GFA AIRWORTHINESS DIRECTIVE

TYPE AFFECTED: PW-5 Serial no.s 17.12.022 to 17.12.024

SUBJECT: Inspection of push rod ends installed in aileron and spoiler drives.

No. BO-17-03-18

Sketch 1: Push-rod end

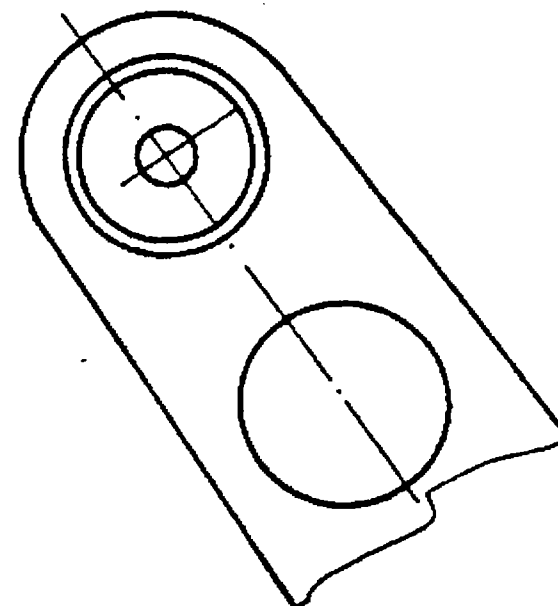
In relation to a case of exceeding the minimum dimension of the push-rod end S/N 511.00.20.00, it is required to make the measurement of all ends installed in the PW-5 sailplane in accordance with the Sketch No. 1 enclosed to this bulletin. The ends are installed in wings in the aileron control system and in the air brakes (altogether 4 pcs per sailplane).

This bulletin is intended to advise the PW-5 sailplane operators that if the dimension defined on the sketch is found to be less than 4.2 mm, the flights should be discontinued and the sailplane must be parked until a particular push-rod end is replaced with a new one.

The activities related with measurement of ends shall be performed by the sailplane operator. In case the measured parameter is less than the acceptable one, a new end must be ordered. For this purpose, send the following information to „PZL-Świdnik” S.A onto the fax No.(+48 81) 468 09 18: sailplane S/N, location of the end installation and measurement result. This shall be the basis for the free-of-charge ordering of a new end at „PZL-Świdnik” S.A. The sailplane manufacturer shall deliver, at his own expense, the new ends S/N 511.00.20.00 and the retaining washers preventing the ends against loosening. The ends shall be replaced with new ones by the operator at his own expense.
